# Access Compliance Report

## Public Rights-of-Way

### (Curb Ramps)

Intersection ID: 49930	Main Street: PAXTON_RUN_RD	Cross Street: CHAMBERLIN_RD	Location: SW
ADA ID: D3C0D979928E	Ramp Type: Perp	Initial Pass/Fail: Fail	Overall Compliance: No
Severity Score: 1.25			
Codes/Mitigation Info/Possible Solution		Field Measurements/Component Compliance

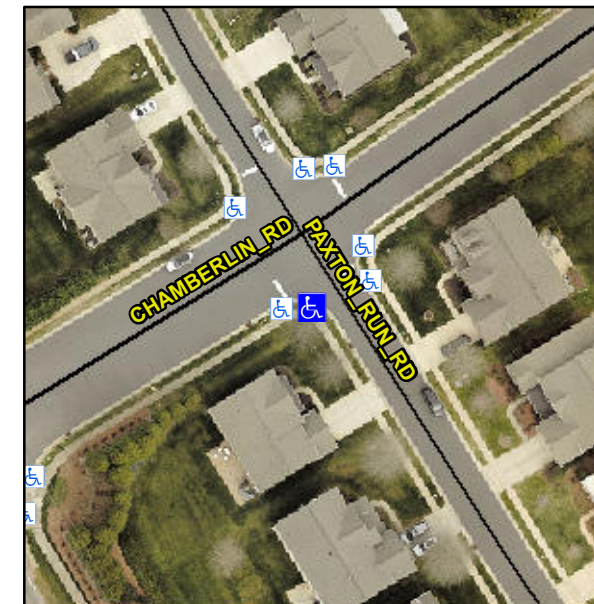
**Not Found, R304.5.3**

Compliance	Description	Data	Compliance	Description	Data
N/A	Ramp Length (in)	47.0	Yes	Ramp Slope (%)	7.3
Yes	Ramp Width (in)	48.0	No	Ramp XSlope (%)	4.3
N/A	Flare Type LT	N/A	N/A	Flare Type RT	N/A
N/A	Flare Slope LT (%)	N/A	N/A	Flare Slope RT (%)	N/A
N/A	Flare Traversable LT?	N/A	N/A	Flare Traversable RT?	N/A
N/A	Landing Length (in)	N/A	N/A	DWS Provided?	N/A
N/A	Landing Width (in)	N/A	N/A	DWS Contrast?	N/A
N/A	Landing Slope (%)	N/A	N/A	DWS Length (in)	N/A
N/A	Landing X Slope (%)	N/A	N/A	DWS Full Width?	N/A
N/A	Landing Curb? (Y/N)	N/A	N/A	DWS Offset (in)	N/A
N/A	Shared Landing?	N/A			
N/A	Gutter Ponding?	N/A	N/A	Gutter Slope (%)	N/A
N/A	Gutter Lip Ht (in)	N/A	N/A	Gutter X Slope (%)	N/A
N/A	Painted X Walk1?	No	N/A	Painted X Walk2?	N/A
	X Walk 1 Direction	To NE		X Walk 2 Direction	N/A
N/A	X Walk 1 Width (in)	N/A	N/A	X Walk 2 Width (in)	N/A
	X Walk 1 Slope (%)	1.3		X Walk 2 Slope (%)	N/A
	X Walk 1 X Slope (%)	4.1		X Walk 2 X Slope (%)	N/A

**Remove & Replace Entire Ramp.**
